COMPLIANCE EVALUATION INSPECTION, SCONZA CANDY COMPANY, OAKDALE FACILITY, STANISLAUS COUNTY

INSPECTION REPORT

FACILITY: Sconza Candy Company
1400 S Yosemite Avenue
Oakdale, CA 95361
Stanislaus County

Figure 1. One of the two groundwater wells currently in-use at the facility. MAF.

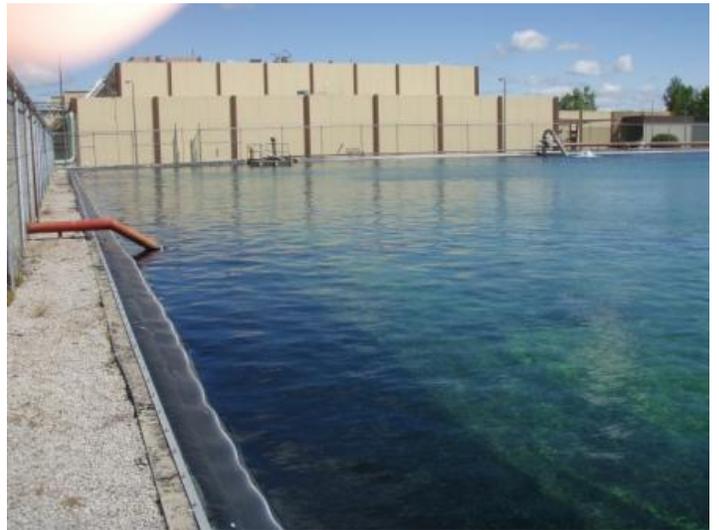
The sources of this water are from four onsite groundwater wells (Figure 1), two of which are currently operable. After use, non-contact cooling water and reject water from a reverse osmosis unit flows into a 1.4 million gallon lined storage pond (Figure 2). The pond is used as a fire sprinkler reservoir and for irrigation water storage. Wastewater discharge to the OID canal (Figure 3) overflows from the pond through a flat weir (Figure 4) and flows through a Parshall flume (Figure 5) prior to entering the OID canal. During a 2008 inspection, it was noted that during certain times of the year, the OID canal water level is higher than the bottom of the Parshall flume that was previously used to measure effluent flow. Because of the location of the Parshall flume, under low effluent flow rate conditions and high OID canal water level conditions, flow measurements using the flume are inaccurate due to water back-flowing from the canal into the flume (Figure 6). An alternate flow measurement technique is currently used. With verbal approval from Central Valley Water Board staff, effluent flow is calculated based on the sum of water supply well flow rates minus the volume of water used for irrigation and the volume of water discharged to the sanitary sewer. The total influent water supply well flow is continuously monitored with a calibrated flow measurement device. According to the discharger, irrigation flow rate is based on the irrigation pump runtime and previous measurements of irrigation flowrate. The sanitary sewer discharge is measured by the city and available on either the monthly sewer bill from the city or by contacting the city's wastewater utilities department.

Figure 8. Current effluent sampling location under very low effluent flow conditions (note water from OID canal present). MAF.

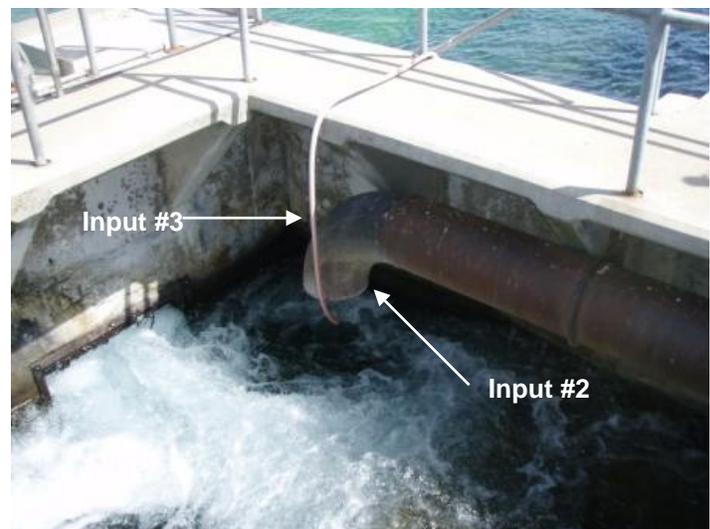
During normal effluent flow conditions, the effluent sample location (Figure 7) currently used is representative of the effluent discharged from the facility. However, during the inspection, it was noted that the water level in the canal can not only interfere with effluent flow rate measurement, but can also compromise the integrity of the effluent water sample under certain conditions. To illustrate this, the Discharger opened an underflow gate to reduce water storage reservoir levels below the level of the effluent weir. After closing the gate, essentially all effluent flow from the storage reservoir had stopped. As shown in Figure 6, standing water that is mixed with OID canal water backs up to the Parshall Flume. The water

level where effluent water samples are currently collected (below the effluent weir, upstream of the Parshall Flume, Figure 8), was equal to the water level in the OID canal. Water at the current effluent sample collection point can potentially mix with OID canal water when extreme low effluent pond discharge flowrate and high OID canal water level conditions are present.

During the inspection, an alternate effluent sample location was discussed. Effluent water samples can be collected from just upstream of the overflow weir (Figure 9) under certain conditions. Order # R5-2002-0111 states:

Figure 10. Input #1 – Well pressure relief outlet. MAF.

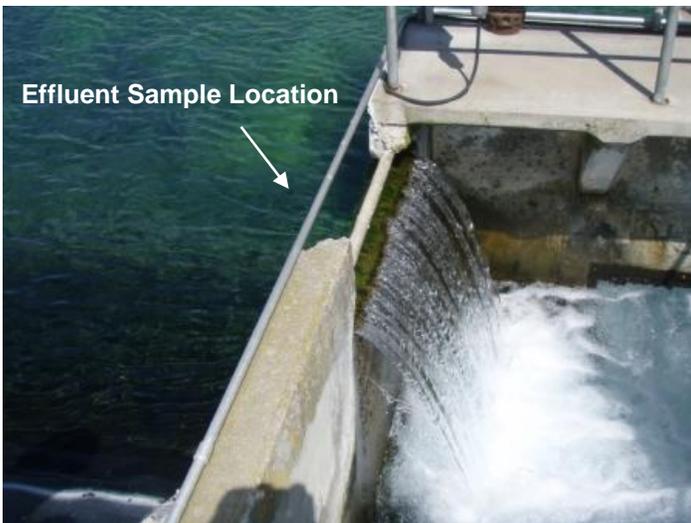
There are several potential inputs to the effluent water flow downstream of the overflow weir. Input #1 is a pressure relief flow from the well piping system that would discharge raw well water into the effluent flow to relieve excess pressure in the water conveyance piping (Figure 10). Input #2 is a pond bypass connected to the pond influent piping that is no longer used (Figure 7). Input # 3 is a hose that was observed hanging over the side of the weir structure, not discharging at the time of the inspection (Figure 7). Since there are several potential inputs to the effluent flow downstream from the overflow weir, the sample can not be collected upstream of the weir unless it is either:

- documented in the cover letter to the self-monitoring report that no flow is observed from these inputs at the time of effluent sampling; or,
- these inputs are either removed, permanently sealed (not possible for the pressure relief flow), or redirected into the pond.

If these conditions are met, moving the effluent sampling location to directly upstream of the overflow weir is acceptable to Central Valley Water Board staff and no enforcement actions will be taken.
